STATE OF NORTH CAROLINA
DEPARTMENT OF TRANSPORTATION

SUBJECT: **Request for Modification of the Section 404 Individual Permit, Section 401 Water Quality Certification, and Neuse River Riparian Buffer Authorization** for the proposed East End Connector from NC 147 (Durham Freeway/Buck Dean Expressway) to north of NC 98 (Holloway Street) in Durham, Durham County, North Carolina, Division 5. Federal Aid Project No. NHF-76-1(2), TIP No. U-0071.

REFERENCE: USACE Individual Permit, Action ID No. SAW-2011-00796, dated March 24, 2014.

In addition to this cover letter, please find enclosed the revised Division of Mitigation Services (DMS) (formerly EEP) Acceptance Letter, revised Wetland Permit Drawing Sheet Nos. 20, 21, 36, 37, 60, 61, 74, 75, 90, and 91 of 91 and Buffer Permit Drawing Sheet Nos. 5 through 7 and 18 of 18.

Permit Drawing
Sheet 21 of 91

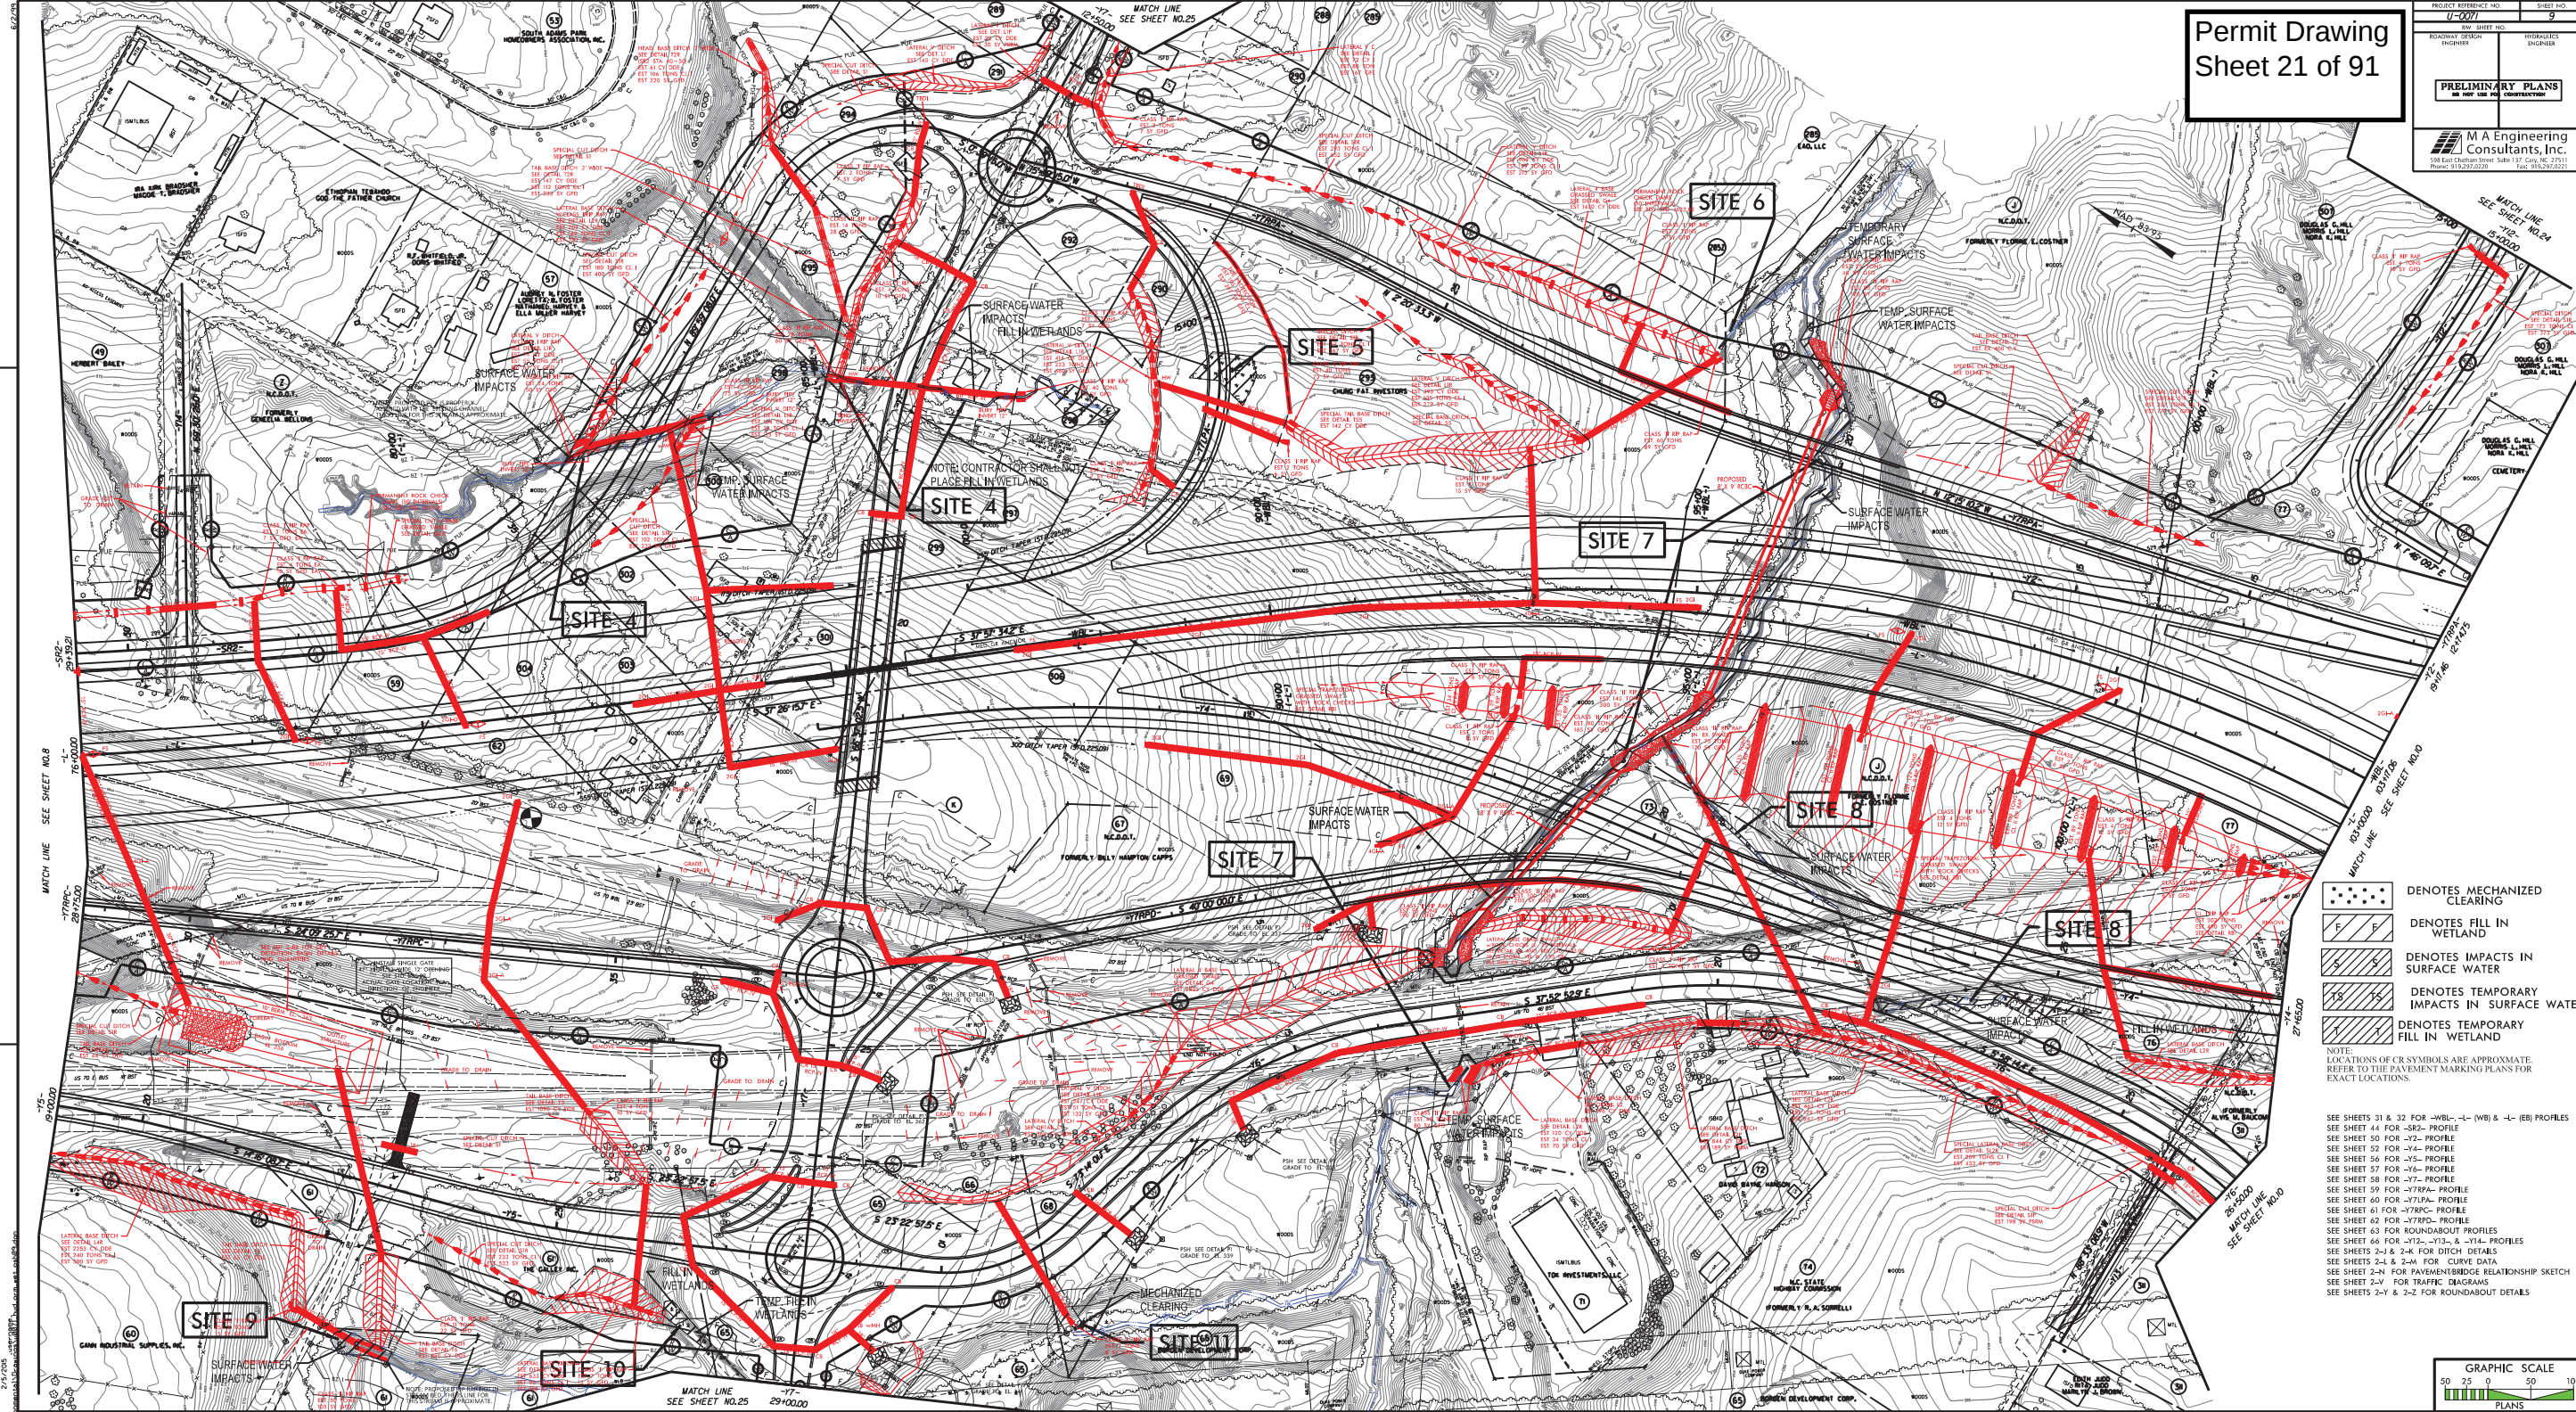
- Site 7: A review of the culvert construction sequence indicates that the tie-in point of the temporary diversion channel at the culvert inlet is located outside of the permitted stream impact footprint. Additional stream impacts are necessary at this site to install the temporary diversion channel at the culvert inlet. There will be a reduction in temporary stream impacts of 6 linear ft. and an increase in bank stabilization of 55 linear ft.

- Sites 17 and 23: A review of the culvert construction sequence indicates that the tie-in points of the temporary diversion channel at the culvert inlet and culvert outlet are located outside of the permitted bank stabilization impact footprint. A review of the stream banks at this location indicates a presence of Triassic rock. Backfilling of the tie-in points of the temporary diversion channel with native soil material will not allow for establishment of suitable streambank vegetation. Accordingly, the revision extends rip rap on the stream banks to fully cover the limits of the tie-in points of the temporary diversion channel. At Site 17, there is a reduction in temporary stream impacts of 11 linear ft. and an increase in bank stabilization of 24 linear ft. At Site 23, there is a reduction in temporary stream impacts of 48 linear ft. and an increase in bank stabilization of 48 linear ft.

2/20/2015
SHEET 18 OF 18

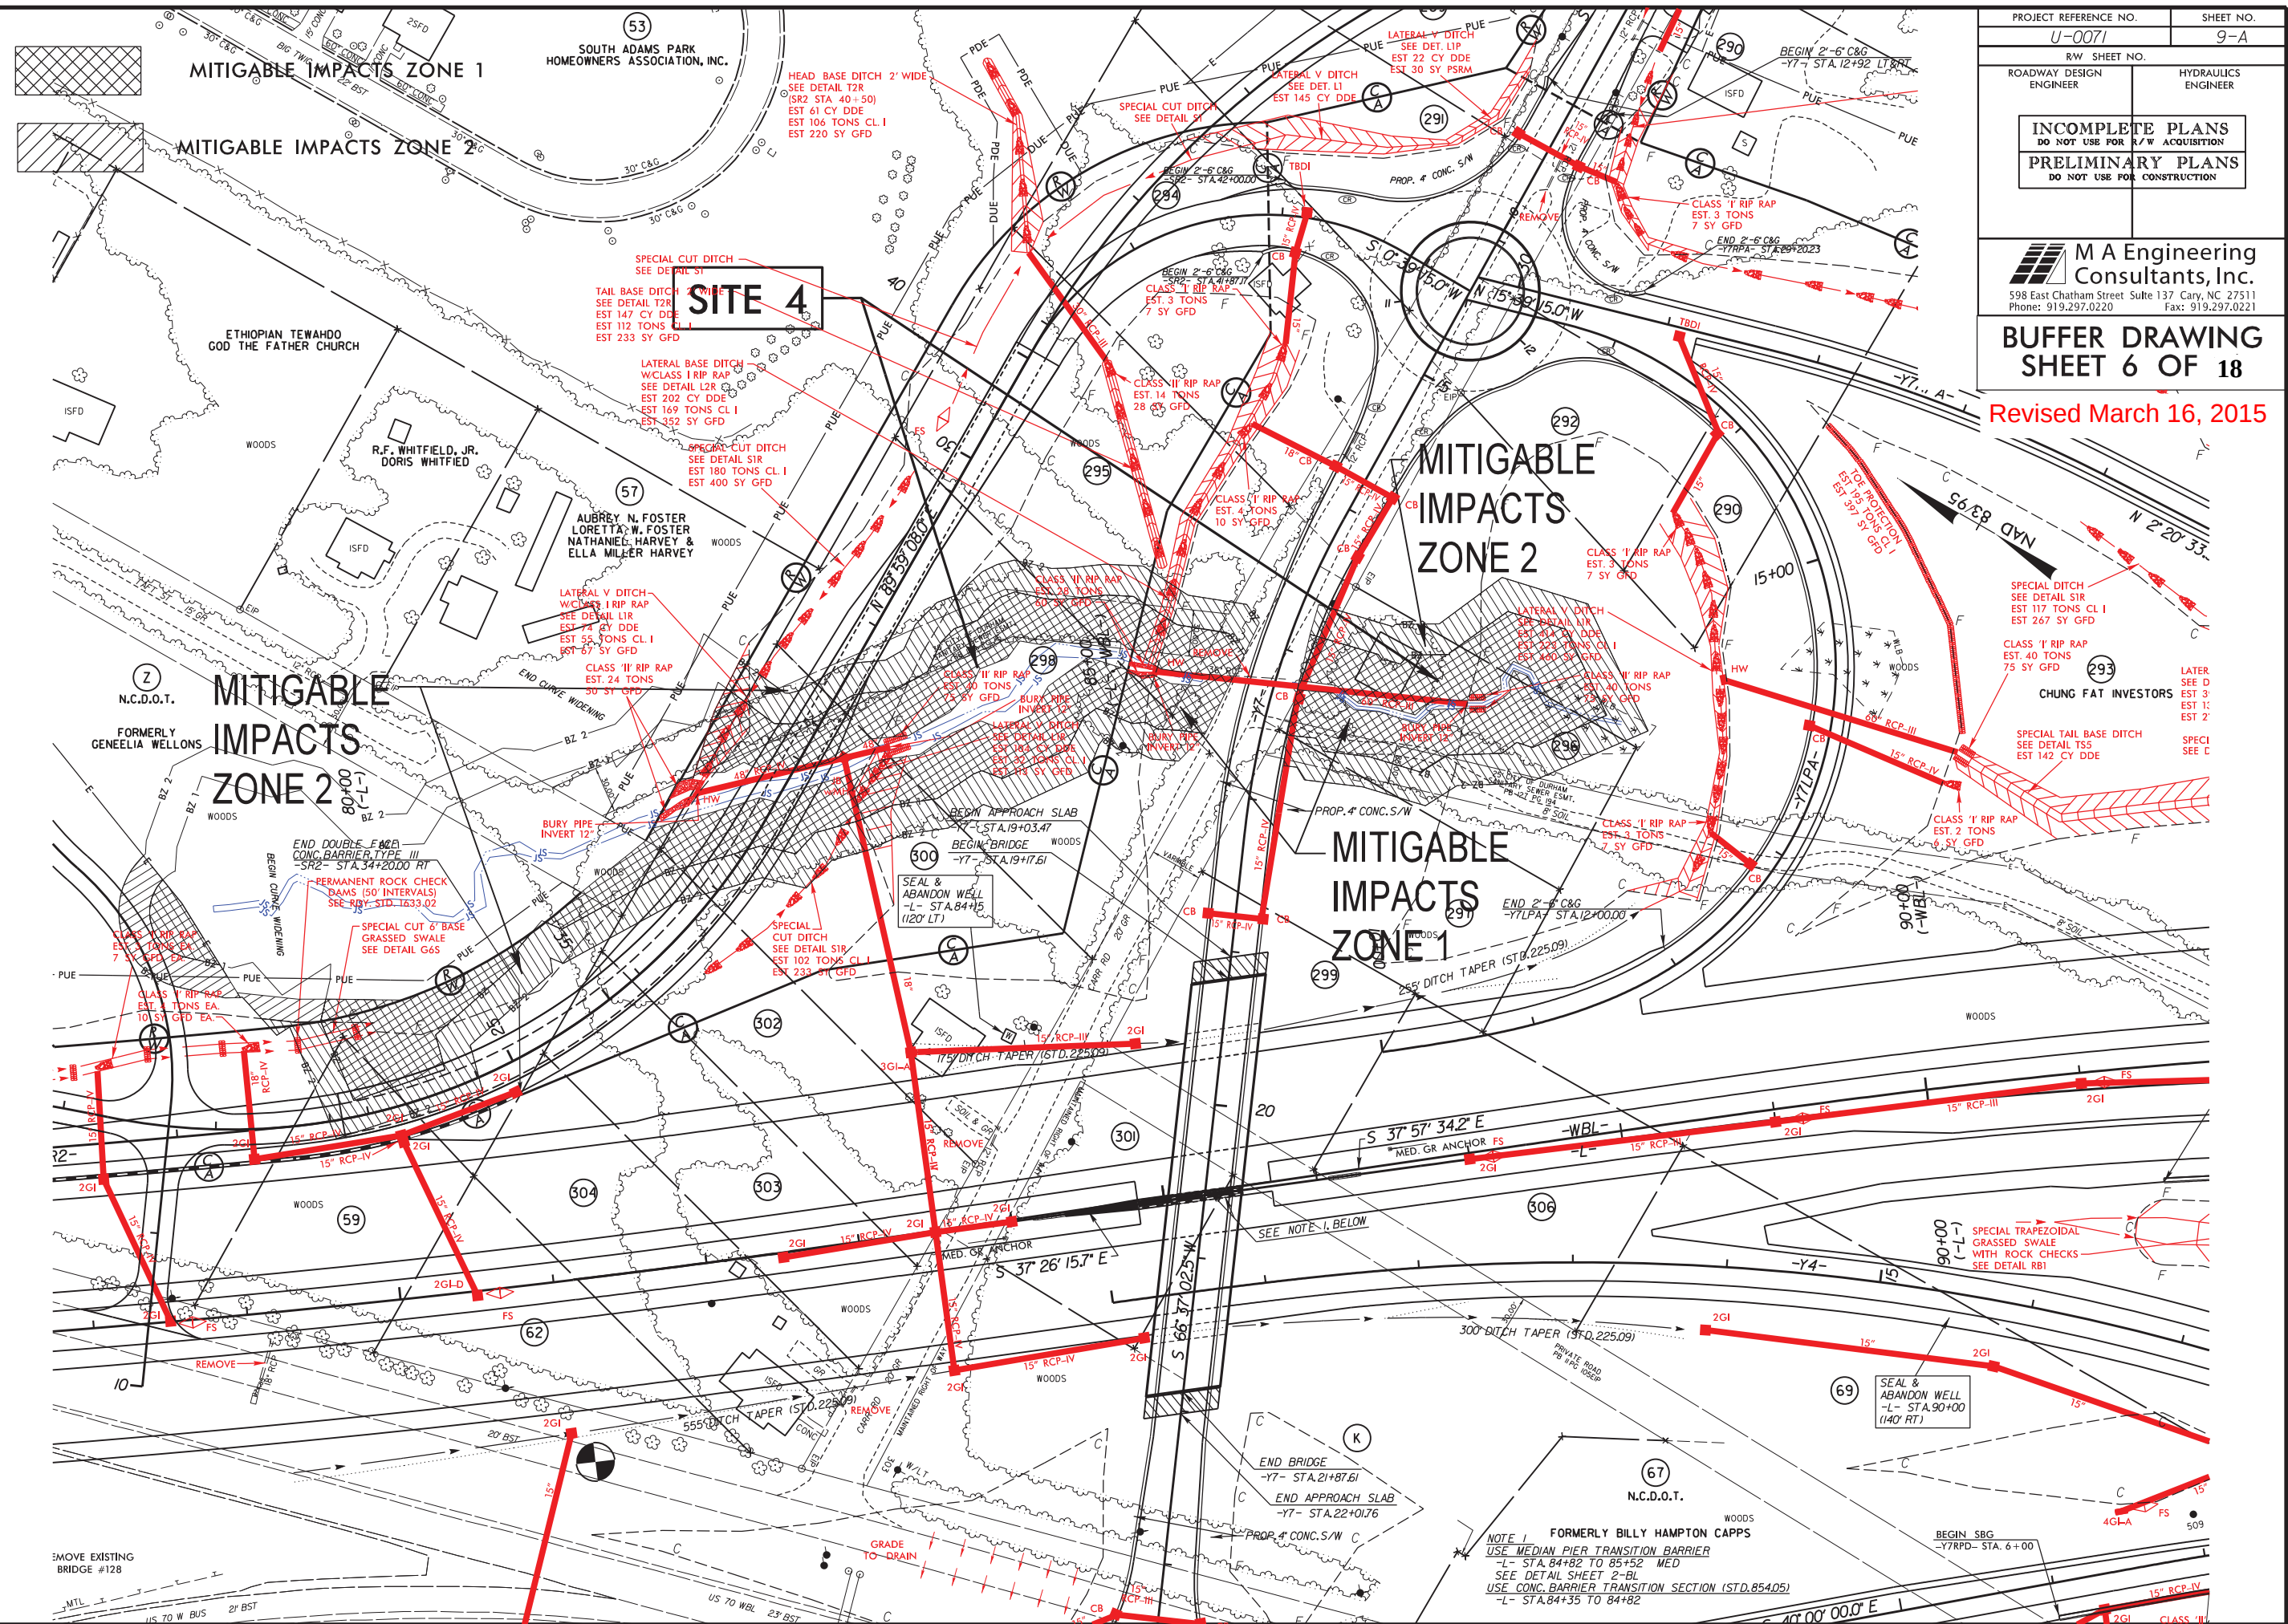
- Site 4: A review of the permit drawings indicates that additional riparian buffer impacts are necessary to allow for construction to install the fill slope and install erosion control devices. There is an increase of 2,560 square ft. of Zone 1 impacts and 135 square ft. of Zone 2 impacts.
- Site 6: This is the same stream as Wetland and Stream Site 7. A review of the culvert construction sequence indicates that the tie-in point of the temporary diversion channel at the culvert inlet is located outside of the permitted riparian buffer footprint. Additional riparian buffer impacts are necessary to install the temporary diversion channel at the culvert inlet. There is an increase of 1,524 square ft. of Zone 1 impacts and 1,228 square ft. of Zone 2 impacts.
